CAMWEST M7 Widening submission

I have prepared this submission on behalf of CAMWEST, a Bicycle NSW affiliated Bicycle User Group with a focus on advocating for and encouraging cycling in the Blacktown, Parramatta, and Cumberland Local Government areas.

In this submission I'm focused on shared path access and continuity during the proposed works in the 9km section of the M7 between Richmond Rd and Old Wallgrove Rd. I also make some proposals that are outside the immediate works corridor but which could enhance existing routes to make them viable detours during the works and as a lasting legacy to the cycling community post completion.

Alt 1 and Alt 2 are existing paths either side of the M7 path in this map.

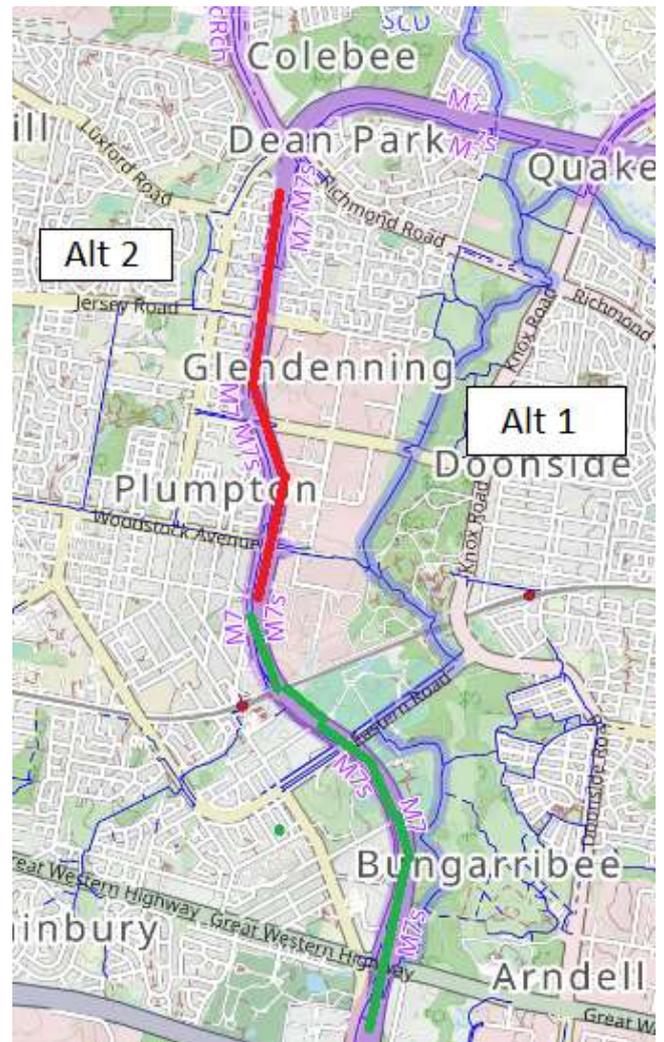
Alt 1 : (Thin blue lines with wider blue background) Western Sydney Parkland Track, which can be entered from the M7 path at two points in the Quakers Hill area, and can be exited at Woodstock Ave, Eastern Rd or followed down to the Great Western Hwy. One advantage of this route is that a lot of it is wider than the recommended minimum width of 2.5m. The route is a lot flatter and quieter than the M7 path, but not as suited to higher speed cycling.

Alt 2: (Thin blue line on map) Richmond Rd to Woodstock Ave shared path via Rooty Hill Rd Nth, Luxford Rd, the Bells Ck reserve corridor, Jersey Rd and Hyatts Rd. This path is longer with traffic light crossings of major roads, plus some uncontrolled crossings of minor roads, driveways and the fairly major Jersey Rd (with a centre refuge). There is a shared path along Woodstock Ave to get back to the M7 path or the Western Sydney Parklands Track. The Hyatts Rd section of the path runs parallel to Rooty Hill Rd North, but west by around 720m. It goes past Plumpton Marketplace Shopping Centre, Plumpton High School and Plumpton Park. Proposal 5 below presents a possible alternative to some of this route.

Map showing the location of the first three proposals. Approximate boundaries of Nurragingy are in blue, gates in black, with red lines being the shared-path proposals described below.

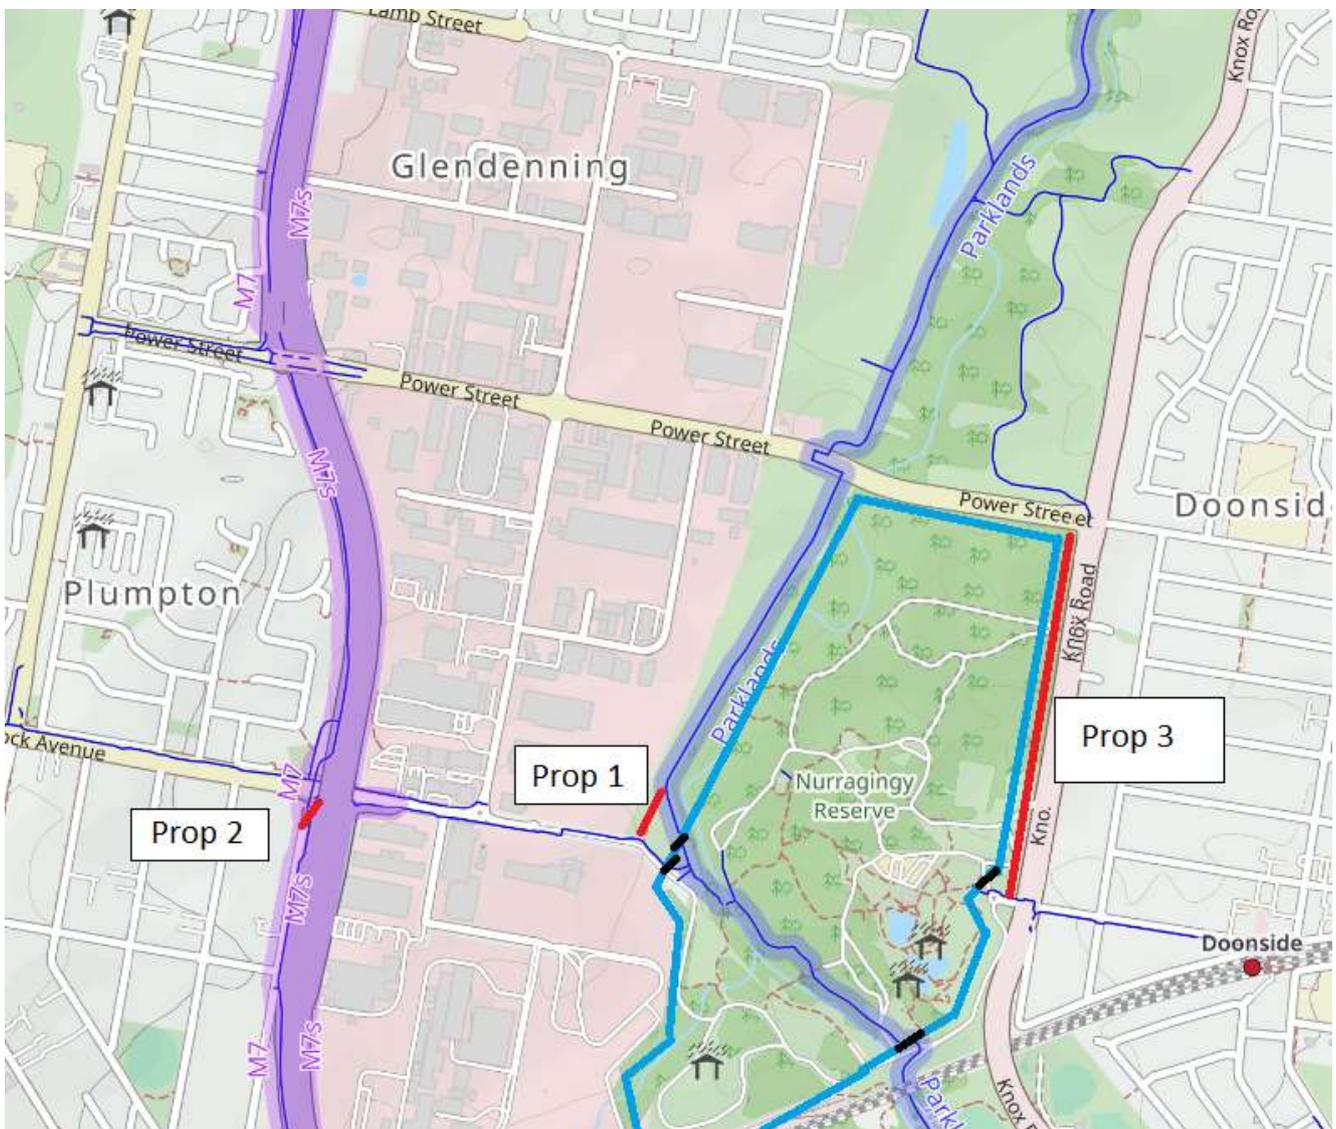
The first three are related to the above Western Sydney Parklands 'Alternative 1' path. I believe they would increase the amenity of this route by ensuring that it is usable 24-hours a day, even when Nurragingy is closed.

Note that Proposals 1 and 2 utilise the shared path on the southern side of Woodstock Ave under the M7 bridge. This may become unusable for the period Woodstock Ave is closed for M7 bridge widening.

Photo below: Standing part way along the track, looking back towards the gate. There is a section of blue metal near the gate which can be tricky to negotiate.

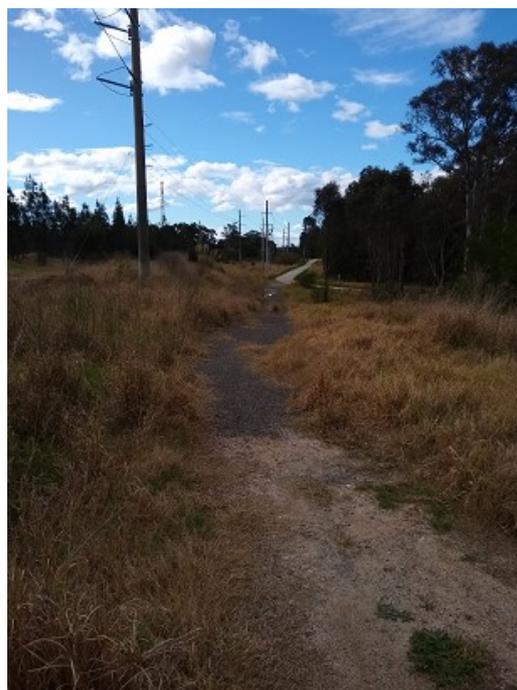
The access road to the Western entrance of Nurragingy Reserve is virtually an extension of Woodstock Ave. There is a shared path which runs alongside the access road and Woodstock Ave, joining the Western Sydney Parklands track within Nurragingy Reserve to the M7 shared path and further west to Rooty Hill Rd North, Hyatts Rd shared path and the Lethbridge Park to Mt Druitt path. There are shared paths on both sides of Woodstock Ave under the bridge and east of the bridge.

There is a 130-metre-long vehicular access track which joins this shared path just outside the Nurragingy access gates with the Western Sydney Parklands Track. The track has a gate at the Nurragingy access road end. Riders can squeeze through the posts beside the gate (if riding a standard bike). The track is composed of dirt/clay and blue metal, and is rideable on bikes with wider tyres, depending on track condition and rider skill level.

The proposal is that the vehicular access track either be converted to a shared path or bitumen surface with a more cycle-friendly entrance at the gate. If this path was in place riders could have ready access between the shared path on Woodstock Ave and the Parklands Track north of Nurragingy Reserve 24 hours a day, without having to pass through the Nurragingy controlled gates.

Proposal 3:

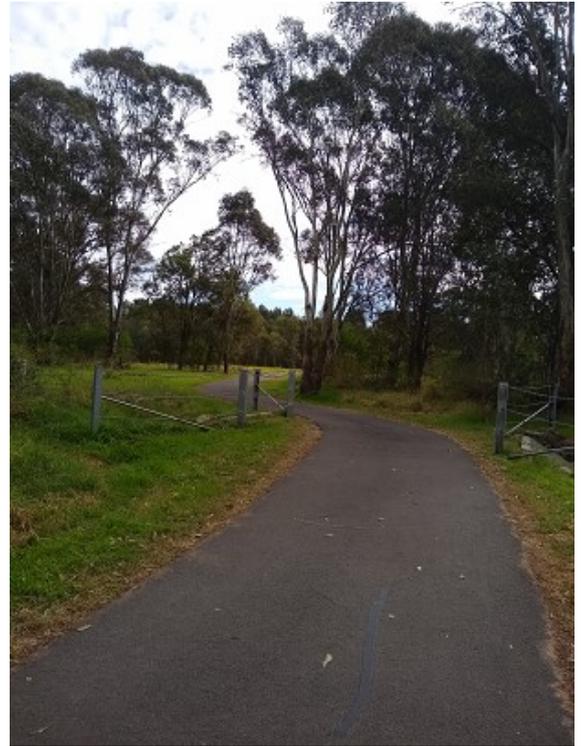
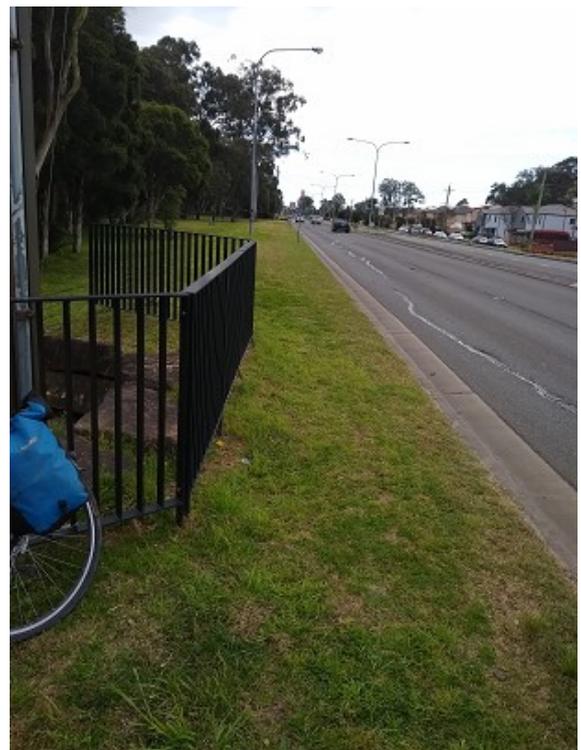
This proposal is for a concrete shared path of approximately 820m in length along the verge on the western side of Knox Rd between Power St and the main access road into Nurragingy Reserve and Charlie Bali Reserve.

Together with existing paths and an access roadway, a route would be provided around the eastern side of the fenced sections of Nurragingy Reserve. This route could be useful if either Woodstock Ave was closed due to bridge widening, or the shared path between the railway line and the Great Western Hwy was impacted by the works (as previously posed).

There is a reasonably wide verge along most of the western side of Knox Rd. As well as crossing the original Nurragingy access road (kerb ramps required), there are three points where the verge narrows:

- One, opposite Evoe Pl, is quite a bit wider than 2.5m;
- The second, just north of the old entrance to Nurragingy, is around 2.5m;
- The third, just north of the main Nurragingy access road is narrower.

Engineering solutions or path re-routing would need to be investigated for at least the third narrowing if this route was to be considered.

Proposal 4:

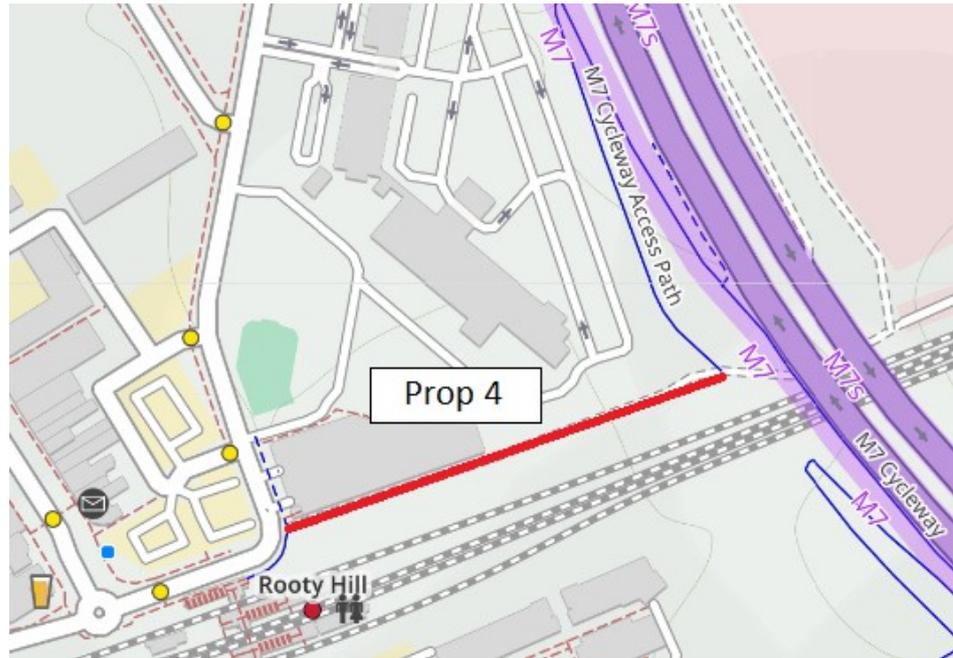
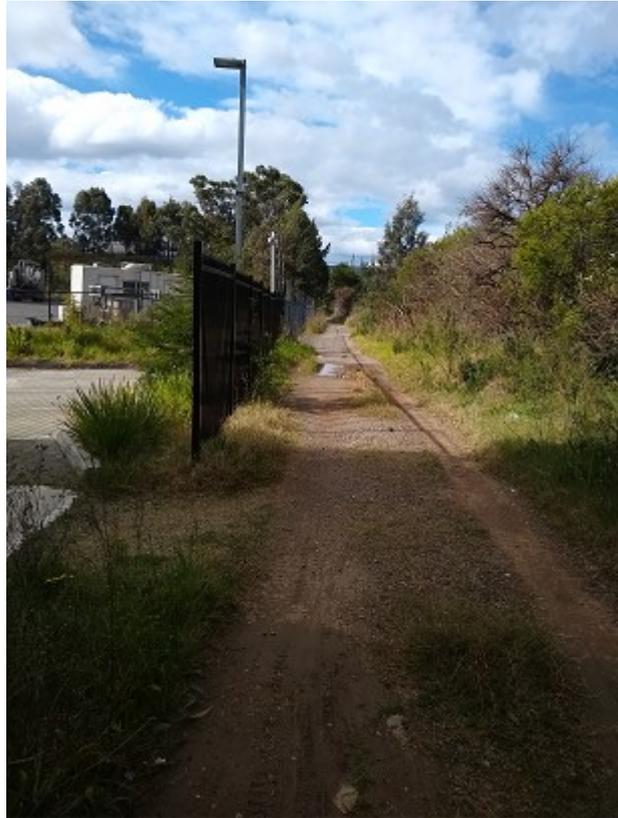
If within scope of the project, this proposal is to replace the existing access track along the northern side of the railway line between Station St Rooty Hill and the bitumen M7 access path with either a bitumen road or shared path. The current access track is around 220m in length. A combination of the recent rains and the construction of the multi-storey commuter carpark has led to a deterioration in the condition of the track.

I was wondering whether this track may be used during the widening of the M7 bridge over the railway line. If so, it may be in the project scope to upgrade it.

Proposal 5:

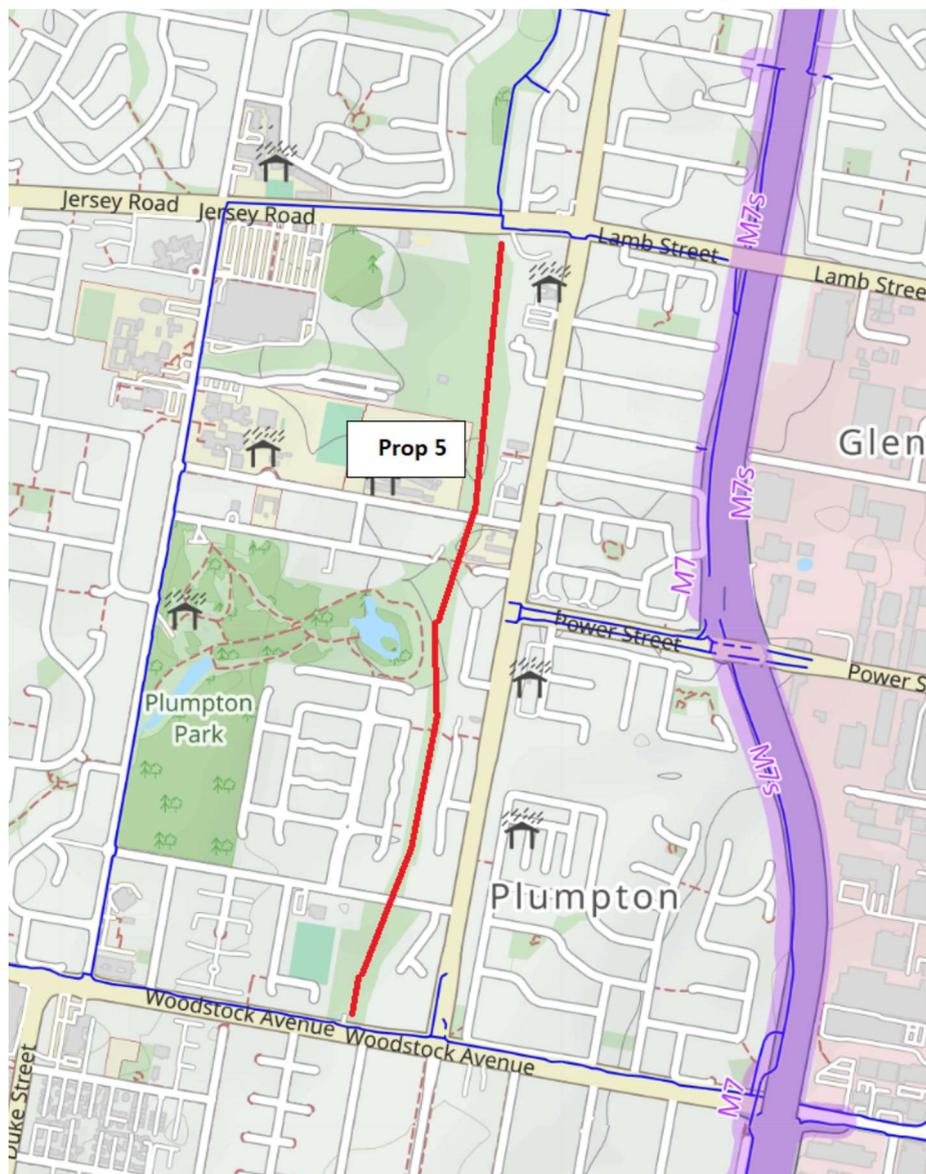
This path may be an alternative to building some or all the diversions along Rooty Hill Rd North. It is approx. 1.7km long if built in its entirety and uses the Bells Ck reserve corridor.

One option to shorten this route may be to widen the footpath along Rooty Hill Rd Nth between Woodstock Ave and Power Street, then divert onto this proposed path from near Power St to Jersey Rd.

Those using this route to divert from the M7 shared path would need to cross Rooty Hill Rd Nth twice, which is less than ideal.

If coming from Richmond Rd, the crossing of Jersey Rd is uncontrolled (although there is a centre refuge).

Although appealing to ride during the day, there may be safety concerns for some at night.

Point 6: **Comments:**

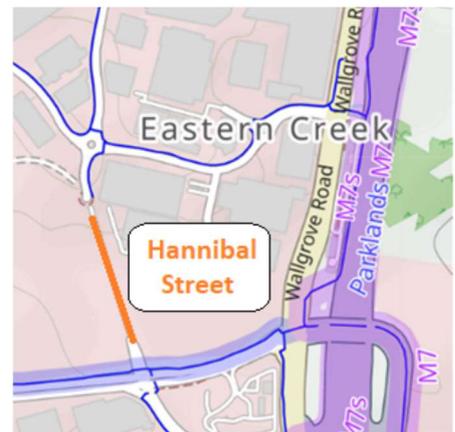
I'm assuming there must be a construction compound along this section of path to necessitate the closure. Some users may find this detour feels eerie or desolate. Although practically it may be the only option (unless building a new path alongside Wallgrove Rd), I think it could be a disincentive for some riders to use this section of the M7 path.

Hannibal St was once part of a private access road, but is now a disused no-through road. The Wonderland Dr end is a reasonably new cul-de-sac named Blue Metal Rd. Although only a short road, it has a shared path part of the way down one side, and safety railings all around.

The no-through-road end of Hannibal St starts just beyond the safety railing and is at a slightly lower elevation. There are presently blocks across the road (which you can squeeze through) before traffic lights at the intersection of Old Wallgrove Rd. There are existing shared paths along Wonderland Drive and Old Wallgrove Rd. Any continuation of the Blue Metal Drive shared path would need a gap in the safety railing to be created and then a ramp built down to Hannibal St. Hannibal St may require a re-surface rather than construction of a shared path.

Map showing two of the possible routes to Station St described above.

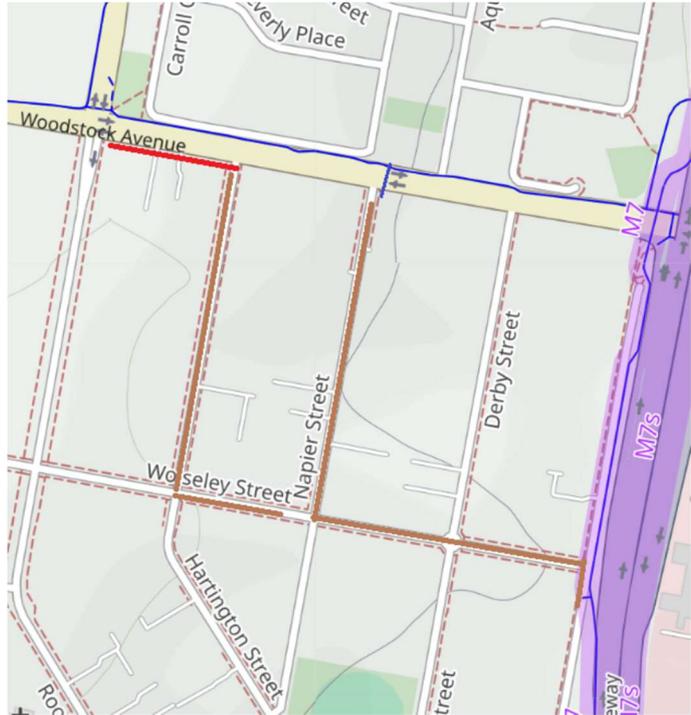
If riders did need to get to Station St instead of Woodstock Ave (maybe because of the works associated with the M7 crossing of Woodstock Ave) there are several options available, but each would require on-road riding along residential streets:

- If not too close to any works at the bridge, riders could cross from the north side of Woodstock to the south using the lights at the corner of the Woodstock Ave M7 exit ramp, then use the path in Proposal 2 to Station St. This is the option with the least traffic.*
- There is an uncontrolled crossing of Woodstock Ave at Napier St with a small refuge island in the middle. Riders could use Napier St and Wolseley to get to Station St. Note that the southern side of Woodstock at this crossing terminates on a footpath. A few metres of path would need to be widened between the crossing and Napier St. Also note there is a new roundabout at the Napier/Wolseley intersection.*

- *If crossing Woodstock Ave at Rooty Hill Rd Nth lights, I'd suggest widening of the footpath to shared path width along the southern side of Woodstock to Hartington St, then on road along Hartington St to Wolseley and then along Wolseley to Station St. Note there is no roundabout at Wolseley/Hartington.*
